ADDENDUM NUMBER TWO
TO PLANS AND SPECIFICATIONS
FOR
NEW COMPLEX FOR WASHINGTON COUNTY ROAD & BRIDGE
BRENHAM, TEXAS

October 23, 2018

PLANNORTH ARCHITECTURAL CO.

1/8" = 1'-0"

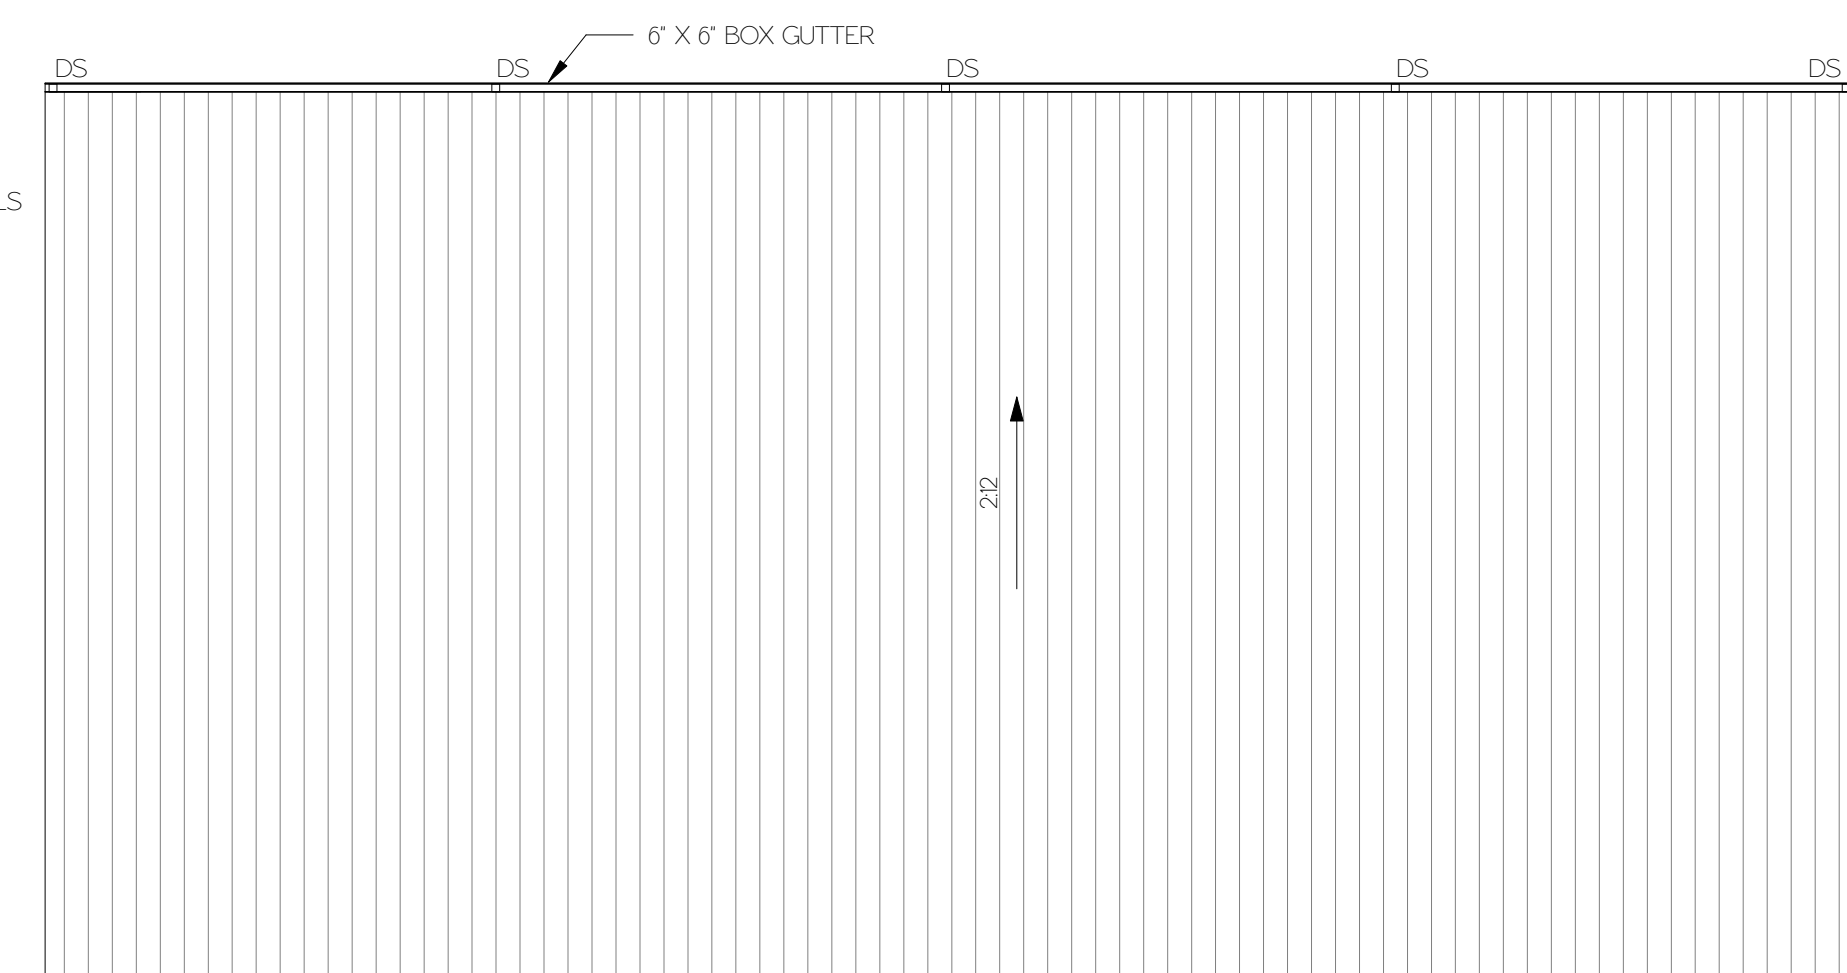
19. A2.04 TIRE & SIGN STORAGE – Add notes related to finishes as shown on the attached Sheet A2.04. Replace entire sheet A2.04.
20. A6.02 BUILDING SECTIONS – SHOP BUILDING – Building Section 1, at COVERED PORCH on right side of section, change note “6”METAL STUDS AT 16” O.C.” to read “8” WALL GIRTS”. Add NEW Wall Section 3. Replace entire sheet A6.02 BUILDING SECTIONS - SHOP BUILDING.
